11792A-01

S E R V I C E N O T E

HP 11792A Sensor Module (Std/Opt 001)

New Coaxial Switch Requires New Mounting Hardware

Figure 1. Mechanical and electrical connections

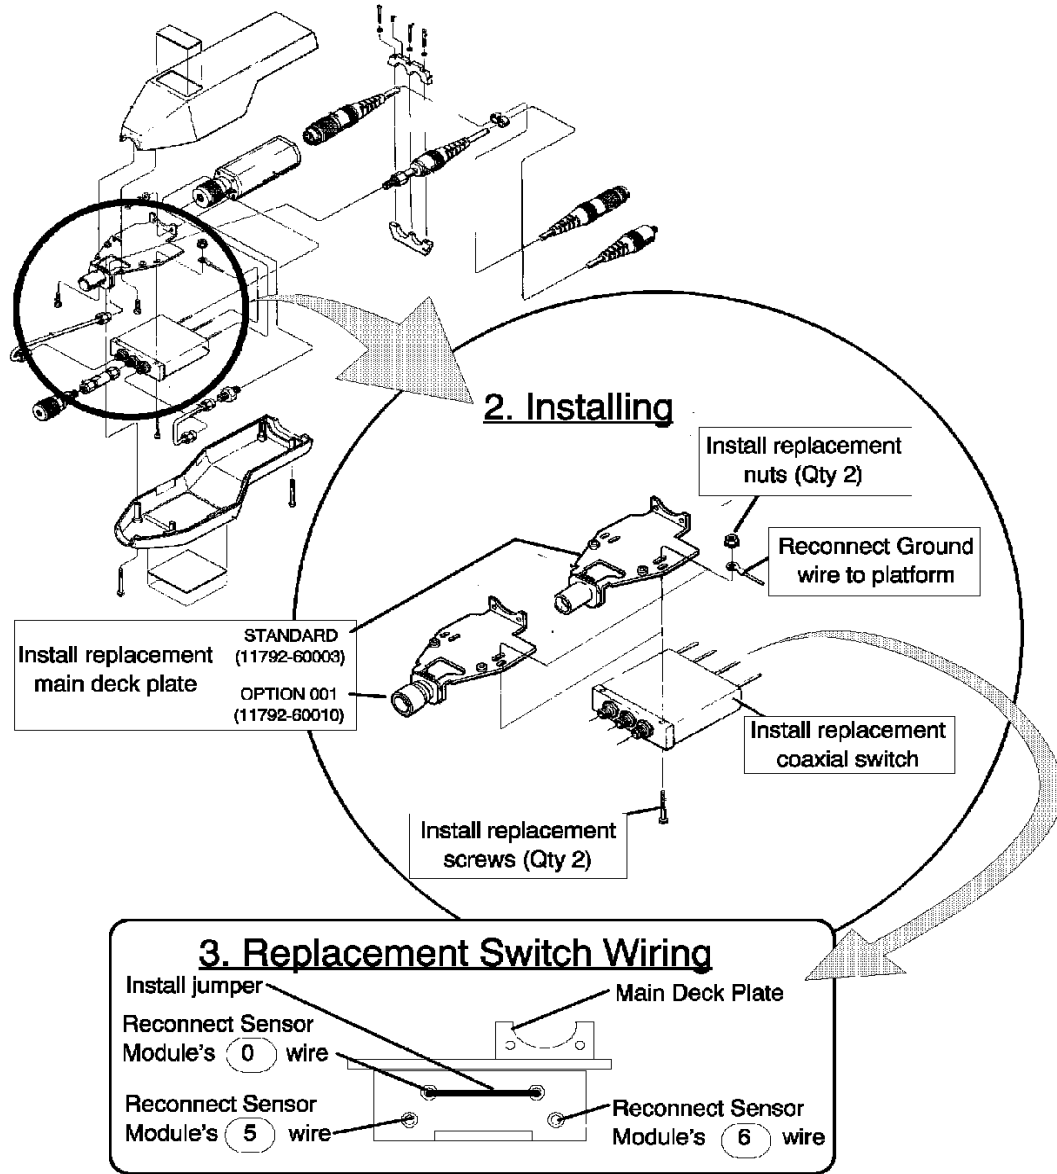
When replacing Coaxial Switch S1 in an 11792A (for serial numbers noted above), replacement of the Main Deck Plate MP1 and associated hardware is required. The new Coaxial Switch (11792-60012) is more reliable and has improved repeatability than the old switch. The part number of the new switch is the same as the old switch. The part number(s) of the replacement Main Deck Plate are the same as the original Main Deck Plate.

Replace original Main Deck Plate MP1 and associated hardware with part numbers (depending on option) noted above. Refer to Figure 1 for correct mechanical and electrical connections. Re-calibration and generation of Calibration Factors for the Sensor Module is recommended after coaxial switch replacement.
